**ROAD SAFETY ROAD SAFETY AUDIT REPORT**  
**Stage 3 - Detailed Design Stage Road Safety Audit**

**ROAD SAFETY AUDIT FOR**  
**PROPOSED RETIREMENT VILLAS**  
**LOT AND DRAINAGE WORKS**

**JORDAN SPRINGS (STAGE 2)**

Ref. 19028 RSA Stage 3

Sight lines at intersection of Road 3 and Driveway 1

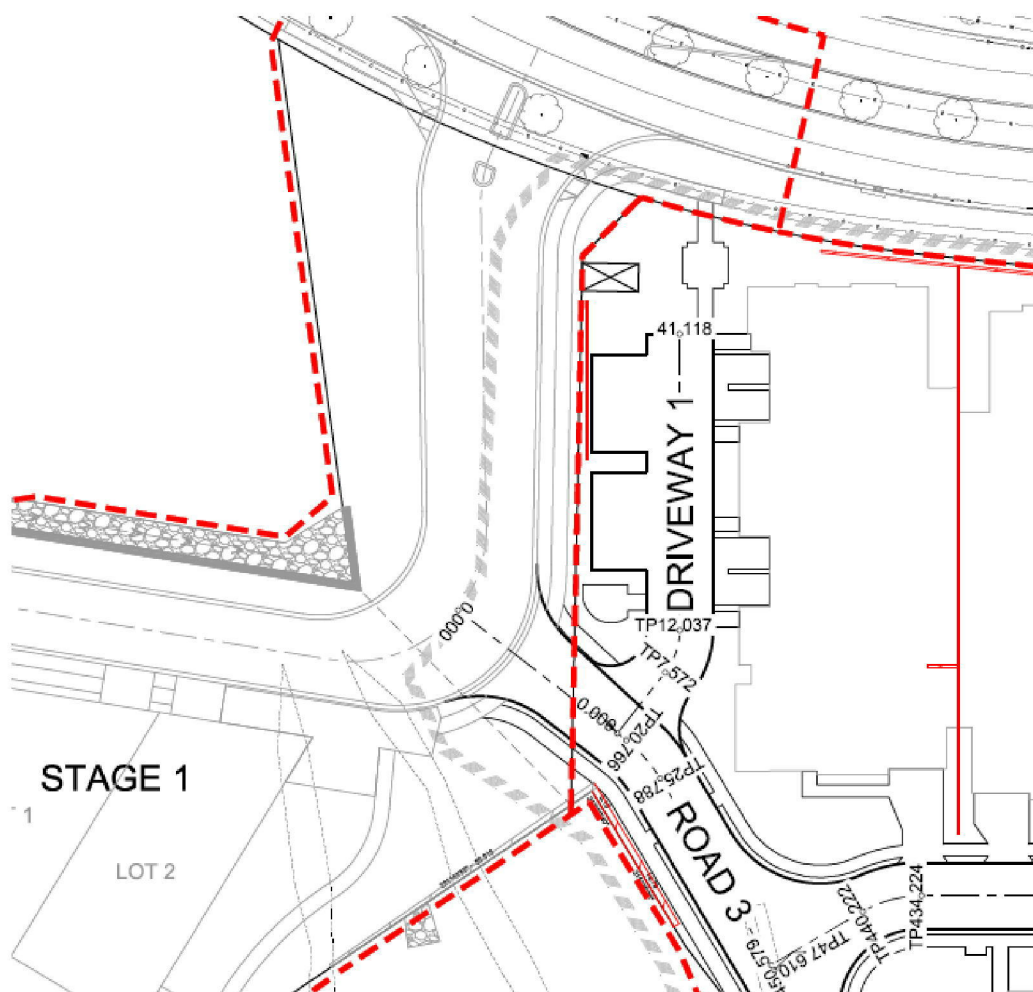
The proposed T-intersection of Road 3 and Driveway 1 is located within 20m of the intersection of Road 3 / Road 1 (Stage 1). The intersection of Road 1 / Road 3 is the only entry point to the Retirement Villa Development.

Sight lines to southbound vehicles entering Road 3 from Road 1 will be limited for vehicles turning right from Driveway 1 due to the road geometry and close proximity of the intersections, which is a potential safety issue.

Consider options to improve sight distance.

Proposed landscaping at intersection of Road 3 and Road 1

Proposed landscaping on the north eastern corner of the intersection of Road 3 / Road 1 has the potential, when mature, to obscure sightlines for vehicles turning right from Driveway 1. The proposed large shrub has a mature height of up to 5m.

If Driveway 1 remains in the current location, consider replacing proposed plantings on north eastern corner of Road 3 / Road 1 with plant species having mature height less than driver eye height or <1.2m.

Item	Issue	Risk Ranking	Response by audit Manager	Other comments including Council/RMS
1	<p>Sight lines to southbound vehicles entering Road 3 from Road 1 will be limited for vehicles turning right from Driveway 1 due to the road geometry and close proximity of the intersections.</p> <p>Consider options to improve sight distance.</p>	Medium / High	<p>Road geometry is heavily constrained at the intersection, and this is a very low speed environment. Street tree planting will be reviewed to maintain maximum sight distance</p>	
2	<p>Proposed landscaping on the north eastern corner of the intersection of Road 3 / Road 1 has the potential, when mature, to obscure sightlines for vehicles turning right from Driveway 1.</p> <p>If Driveway 1 remains in the current location, consider replacing proposed plantings on north eastern corner of Road 3 / Road 1 with plant species having mature height less than driver eye height or &lt;1.2m.</p>	Medium / High	<p>Driveway 1 needs to remain in its current location. Landscape design to be amended to limit height of plantings in north eastern corner to 1m.</p>
